Access Compliance Report

Public Rights-of-Way

Intersection ID: 18018	Main Street: GILMORE_DR	Cross Street: INWOOD_DR	Location: SW
ADA ID: 17BF0A330CF1	Ramp Type: BlendTrans2	Initial Pass/Fail: Pass	Overall Compliance: No
		Severity Score: 12.75

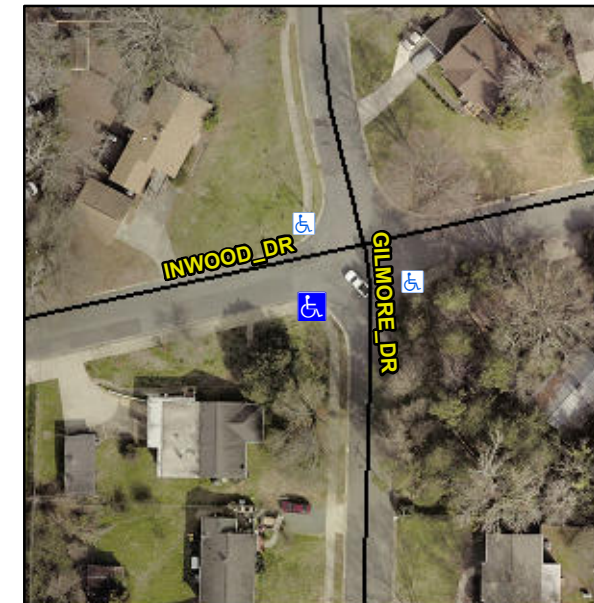
Not Found, R304.5.3, R302.7.2, R304.5.4

Compliance	Description	Data	Compliance	Description	Data
N/A	Ramp Length (in)	71.0	Yes	BlendTrans Slope (%)	4.6
Yes	Ramp Width (in)	48.0	No	BlendTrans XSlope (%)	2.9
N/A	Flare Type LT	None	N/A	Flare Type RT	None
N/A	Flare Slope LT (%)	N/A	N/A	Flare Slope RT (%)	N/A
N/A	Flare Traversable LT?	N/A	N/A	Flare Traversable RT?	N/A
N/A	Landing Length (in)	N/A	Yes	DWS Provided?	Yes
N/A	Landing Width (in)	N/A	Yes	DWS Contrast?	Yes
N/A	Landing Slope (%)	N/A	Yes	DWS Length (in)	24.0
N/A	Landing X Slope (%)	N/A	Yes	DWS Full Width?	Yes
N/A	Landing Curb? (Y/N)	No	Yes	DWS Offset (in)	0.0
N/A	Shared Landing?	No			
Yes	Gutter Ponding?	No	No	Gutter Slope (%)	6.8
No	Gutter Lip Ht (in)	0.5	No	Gutter X Slope (%)	2.6
N/A	Painted X Walk1?	No	N/A	Painted X Walk2?	No
	X Walk 1 Direction	To E		X Walk 2 Direction	To N
	X Walk 1 Width (in)	N/A		X Walk 2 Width (in)	N/A
	X Walk 1 Slope (%)	7.3		X Walk 2 Slope (%)	2.8
	X Walk 1 X Slope (%)	0.7		X Walk 2 X Slope (%)	4.1

N/A	Ramp inside XWalk1?	N/A	N/A	Ramp inside XWalk2?	N/A
	Road Slope (%)	0.6		Clear Space?	Yes
	Road X Slope (%)	5.2	N/A	Clear Space to XWalk (in)	N/A
Yes	Any Obstructions?	No	Yes	Storm Grate/Utility Hazard?	No
	Obstruction Type			Storm Grate/Utility Type	
		N/A			N/A
			Yes	Surface Condition? (G/P)	Good
			No	Curb Slope (%)	20.5

Remove & Replace Curb Ramp With Two New Directional Ramps or Equivalent. Remove & Replace Gutter.
